SUBJECT: FAS Route 1652 (US 45)
Project ACRS-1652 (002)
Section (13,14,14-1Z)RS-4
Shelby and Cumberland Counties
Contract No. 74693
Item No. 112, March 3, 2017 Letting
Addendum B

NOTICE TO PROSPECTIVE BIDDERS:

1. Revised pages 7-12 of the Special Provisions

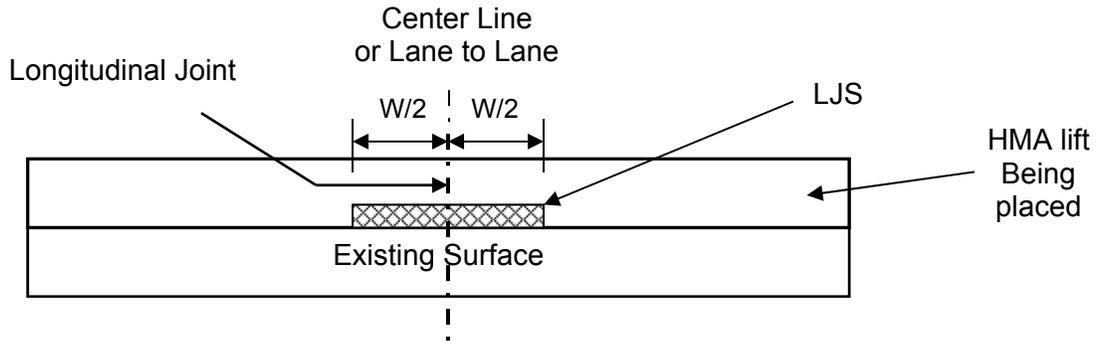
- “(2) Longitudinal Joints. Unless prohibited by stage construction, any HMA lift shall be complete before construction of the subsequent lift. The longitudinal joint in all lifts shall be at the centerline of the pavement if the roadway comprises two lanes in width, or at lane width if the roadway is more than two lanes in width.

When stage construction prohibits the total completion of a particular lift, the longitudinal joint in one lift shall be offset from the longitudinal joint in the preceding lift by not less than 3 in. (75 mm). The longitudinal joint in the surface course shall be at the centerline of the pavement if the roadway comprises two lanes in width, or at lane width if the roadway is more than two lanes in width.

A notched wedge longitudinal joint shall be used between successive passes of HMA binder course that has a difference in elevation of greater than 2 in. (50 mm) between lanes on pavement that is open to traffic.

The notched wedge longitudinal joint shall consist of a 1 to 1 1/2 in. (25 to 38 mm) vertical notch at the lane line, a 9 to 12 in. (230 to 300 mm) wide uniform taper sloped toward and extending into the open lane, and a second 1 to 1 1/2 in. (25 to 38 mm) vertical notch at the outside edge.

The notched wedge longitudinal joint shall be formed by the strike off device on the paver. The wedge shall then be compacted by the joint roller.
